# PERMIT

SEWAGE DISPOSAL SYSTEM  
HOWARD COUNTY HEALTH DEPARTMENT  
BUREAU OF ENVIRONMENTAL HEALTH  
410-313-2640

P 515000

SUBDIVISION Vinyards at Cattail Creek LOT NUMBER 1 ADDRESS 3595 Willow Birch Drive

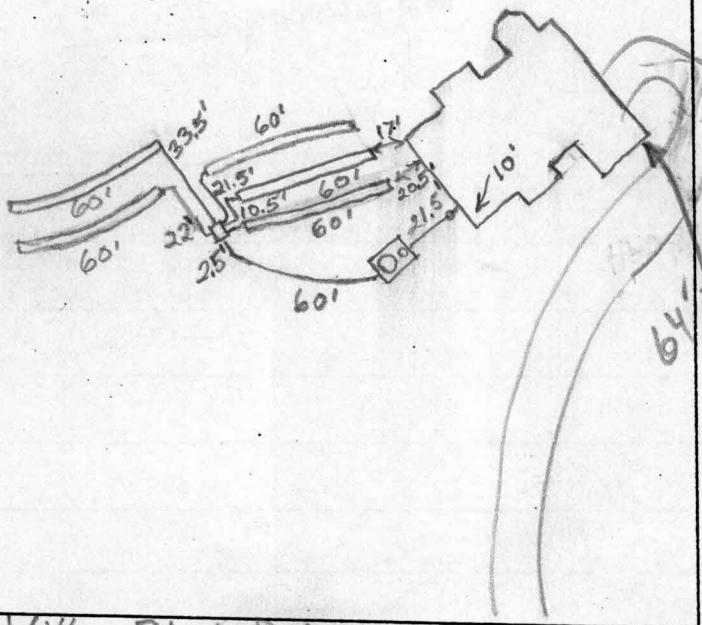
Willow Birch Drive  
PRE-CONSTRUCTION INSPECTION: 4/30/01 Was layout done. Don't see any  
easement stakes. BB

INSPECTION COMMENTS: 4/30/01 No house connection. When was layout done?  
No wall check. O.K. to cover. Well may be too close to driveway BB  
5/1/01. Spoke to builder about inspection procedures. Installer was notified BB  
8/7/01 HOUSE CONN OK (MR)
